## **Metro Outer Joint Development Assessment Panel Agenda**

Development Description:	Proposed Fast Food Outlet
Applicant:	Planning Solutions Pty Ltd
Owner:	MGP Baldivis Pty Ltd
Responsible Authority:	City of Rockingham
DAP File No:	DAP/21/02069

**Approve** DAP Application reference DAP/21/02069 and accompanying plans as contained within Attachment 1:

### Directional Signage

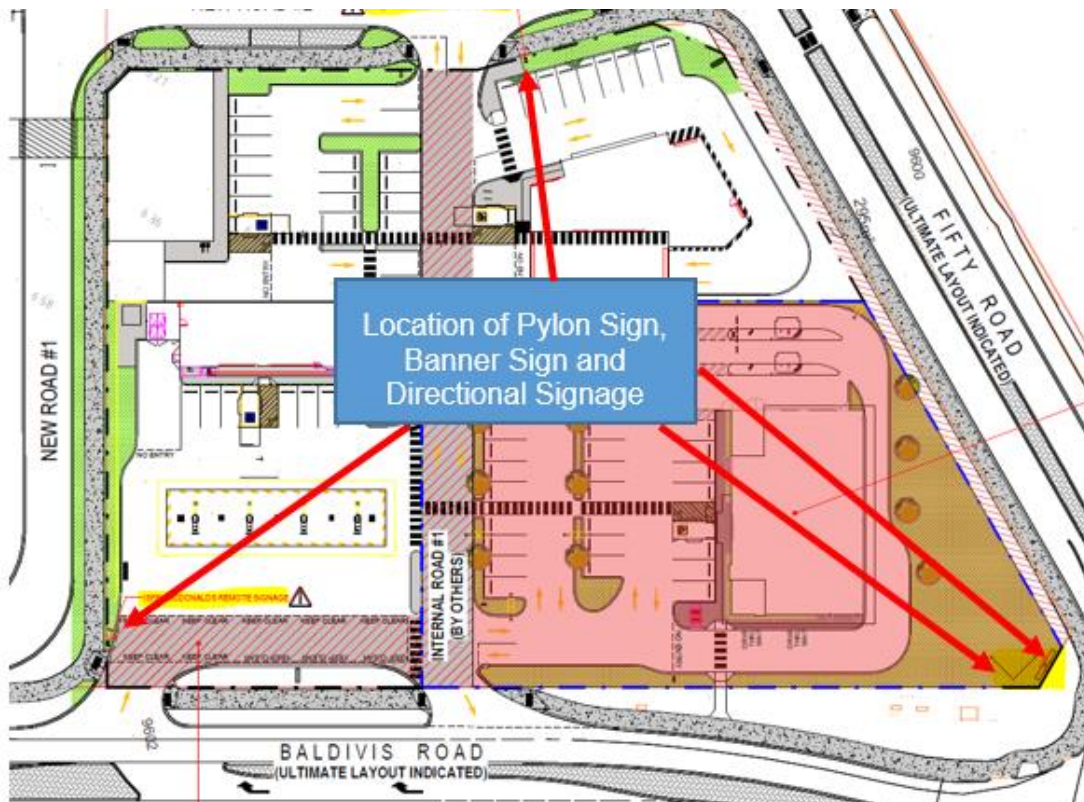
There are five (5) directional signs which are considered too many. Two (2) of these signs are located outside the development site (i.e. one on future Service Station site adjacent to the southern boundary and one on the future Liquor Store - Small site adjacent to the western boundary of the Local Commercial Centre). The City considers that these advertising signs should be removed to limit over-proliferation of signage.

9. The proposed Pylon Sign must be modified to a maximum height of 9.0m.
10. The proposed Banner Signage is excluded from this Development Approval.
11. The proposed Directional Signage outside the development boundaries of the Fast Food Outlet site is excluded from this Development Approval.

Scale 1:300 @ A3	Series BIO_MOD
Drawing <b>PROPOSED LANDSCAPING PLAN</b>	
Project Number <b>0743</b>	Drawing Number <b>DA04</b>
Issue

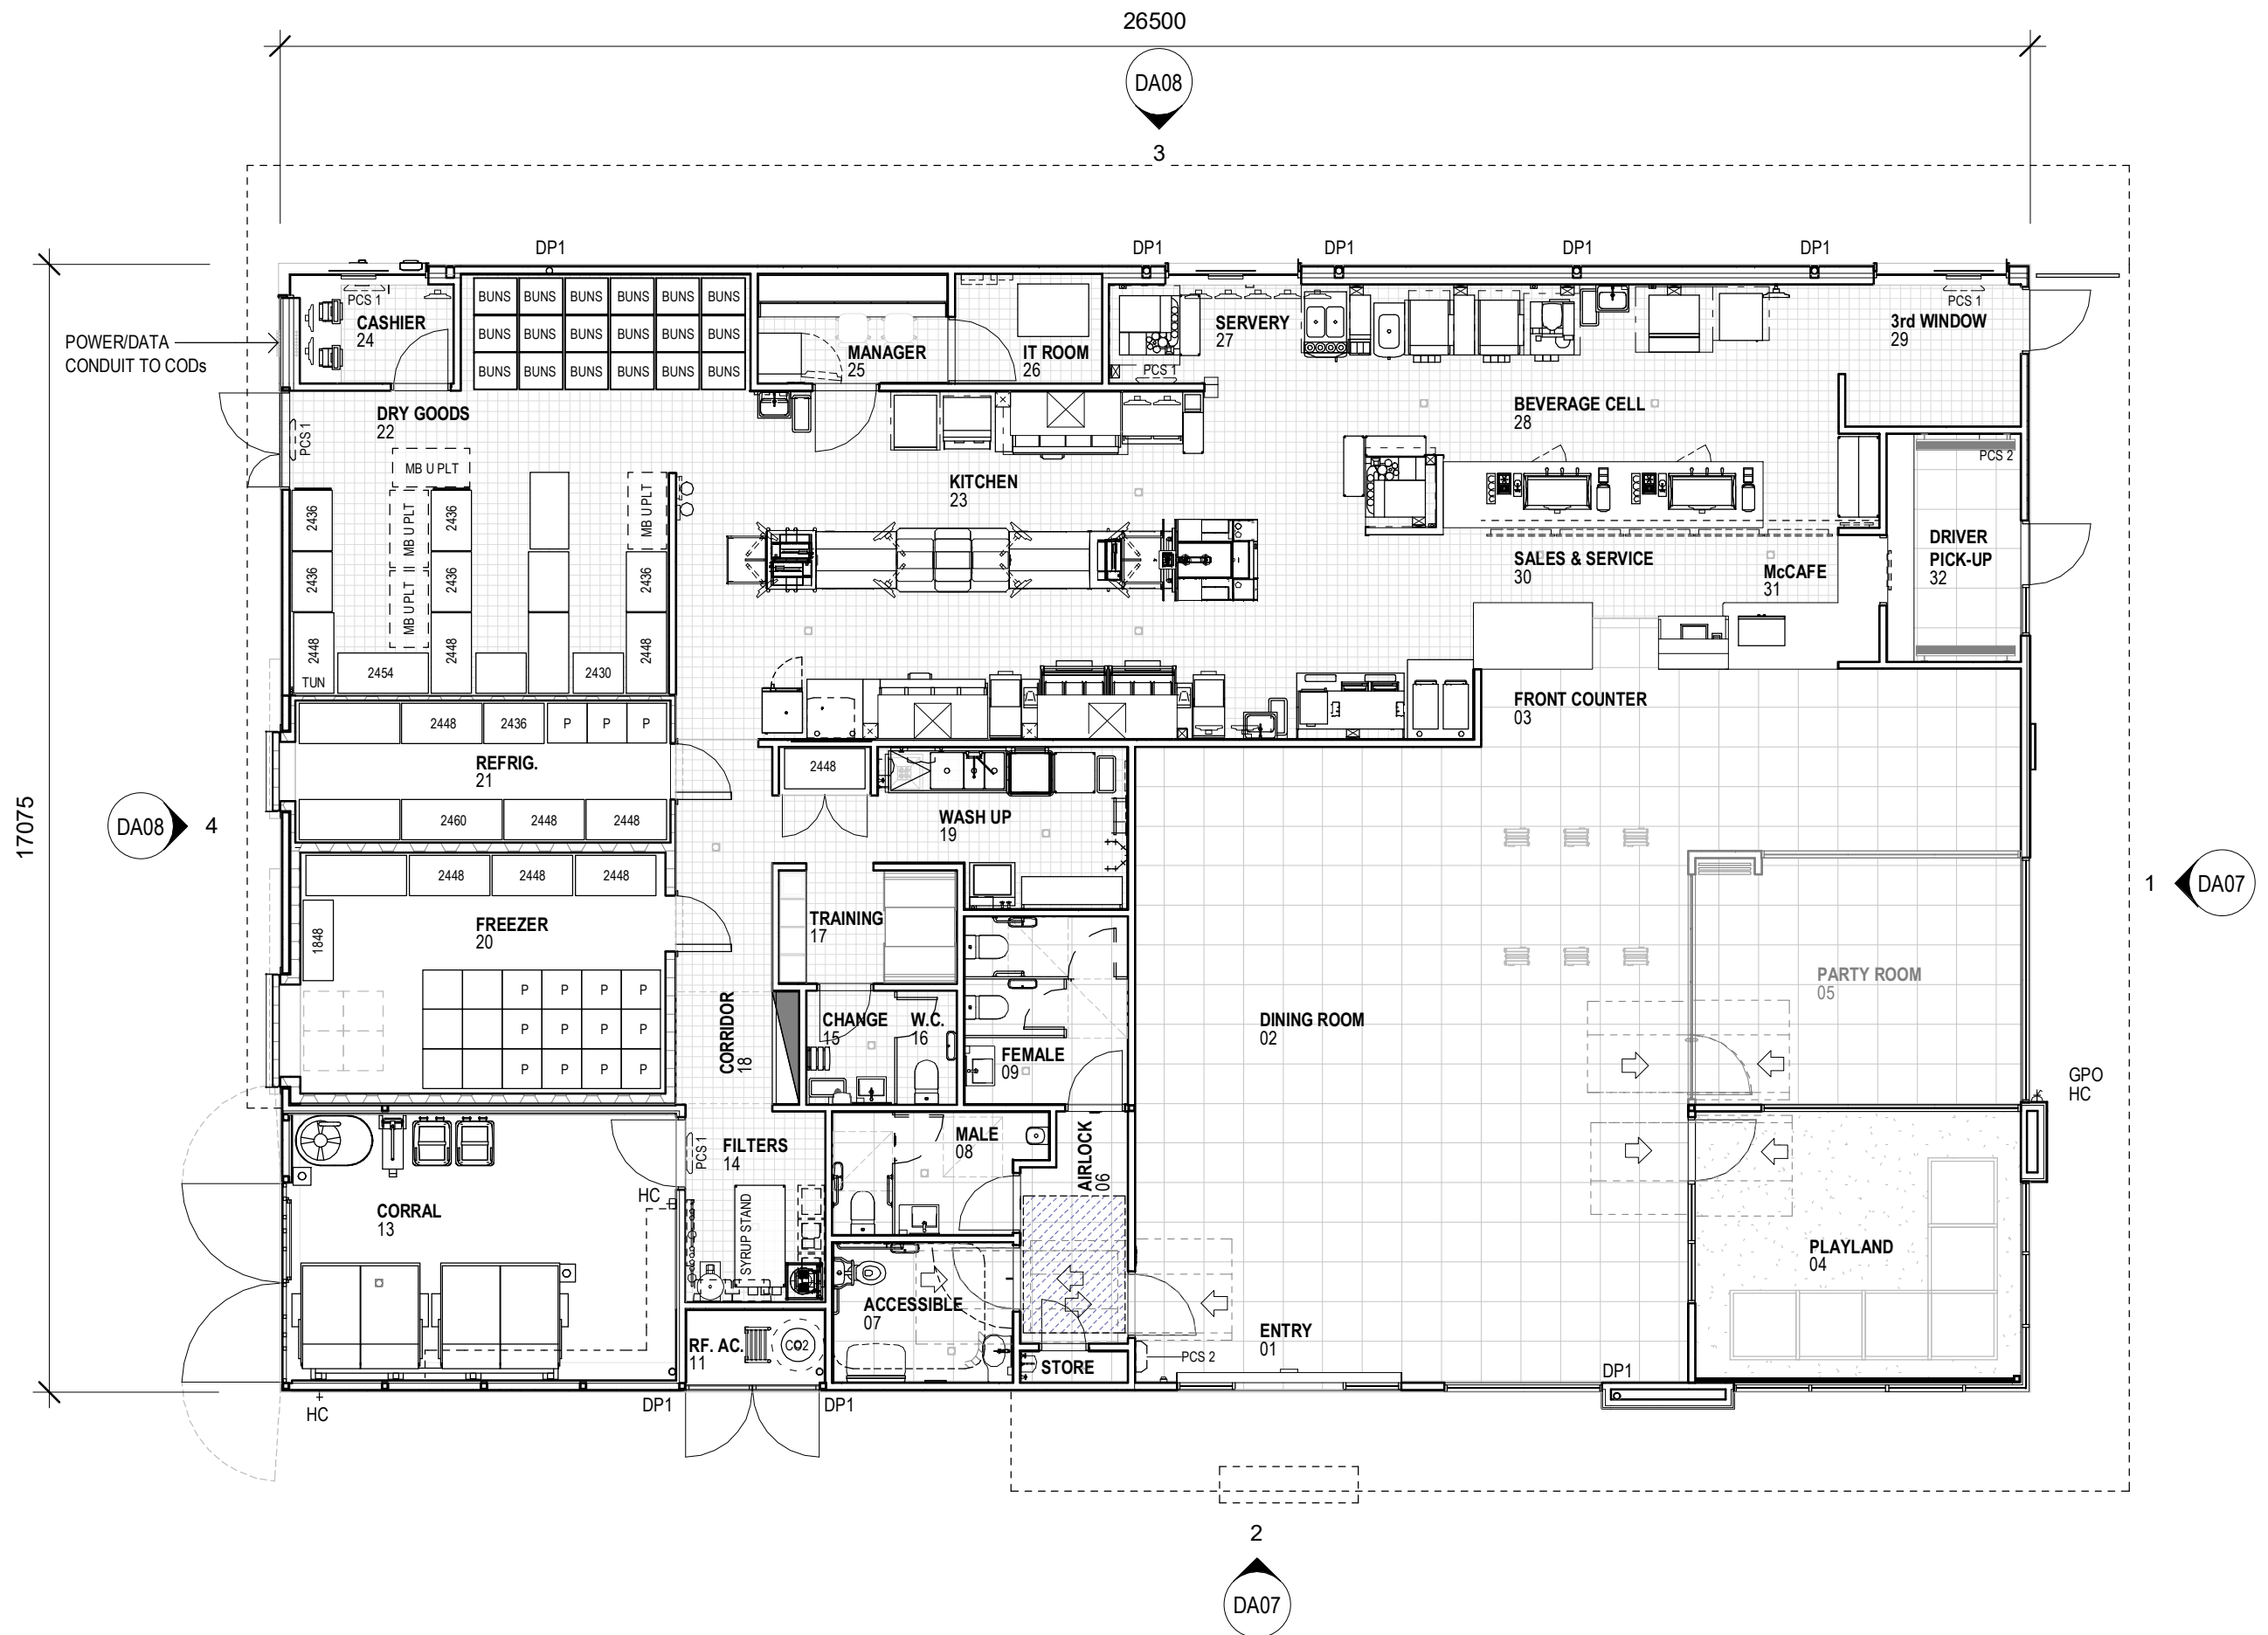
5. A revised Landscaping Plan must be prepared and include the following detail, to the satisfaction of the City, prior to applying for a Building Permit:

- (vii) Install five (5) additional trees along the Baldivis Road boundary, two (2) trees within the carpark planted nibs and one (1) additional tree along Fifty Road boundary. All trees are to be a minimum of 200Ltr.

Condition	Proposed modification to condition	Justification
5	<p><i>A revised Landscaping Plan must be prepared and include the following detail, to the satisfaction of the City, prior to applying for a Building Permit:</i></p> <ul style="list-style-type: none"> <li><i>(i) The Location, number and type of <del>existing and</del> proposed trees and shrubs (including street trees, shade trees within the car parking areas, indicating calculations for the landscaping area;</i></li> <li><i>(ii) Any lawns to be established and areas to be mulched;</i></li> <li><i>(iii) Any natural areas/trees to be retained;</i></li> <li><i>(iv) Those areas to be reticulated or irrigated as part of a strategy for internal/external areas;</i></li> <li><i>(v) Irrigation plans for all planted areas including the adjoining verge areas;</i></li> <li><i>(vi) Proposed upgrading to landscaping, paving and reticulation of the street setback area and all verge areas, including ongoing maintenance;</i></li> <li><i>(vii) Install five (5) additional trees along the Baldivis Road boundary, two (2) trees within the carpark planted nibs and one (1) additional tree along Fifty Road boundary. All trees are to be a minimum of 200Ltr.</i></li> </ul> <p><i>The landscaping (including all verge landscaping) must be completed prior to the occupation of the development by the operator or landowner, and must be maintained at all times to the satisfaction of the City of Rockingham.</i></p>	<p>We request Condition 5 be <b>modified</b> for the following reasons:</p> <ul style="list-style-type: none"> <li>The proposed development does not seek to retain the trees outlined by the City's officers within the RAR. The removal of the specific requirement on the condition to retain 'existing' trees and shrubs removes the uncertainty in respect to which existing trees on the subject site are to be retained.</li> <li>The location of the proposed pylon sign is in accordance with the approved Lot 1 Fifty Road Local Development Plan (LDP). The retention of the existing trees adjacent to the truncation will render the proposed signage redundant as it will reduce the visibility of the signs from the surrounding road network.</li> <li>The proposed amendment to the condition will provide the necessary certainty and clarity to ensure the landscaping plan is prepared with a clear set of parameters. The modified wording will not undermine the overall landscaping for the site as the landscaping design is in excess of the landscaping requirements required in accordance with the planning framework.</li> </ul>
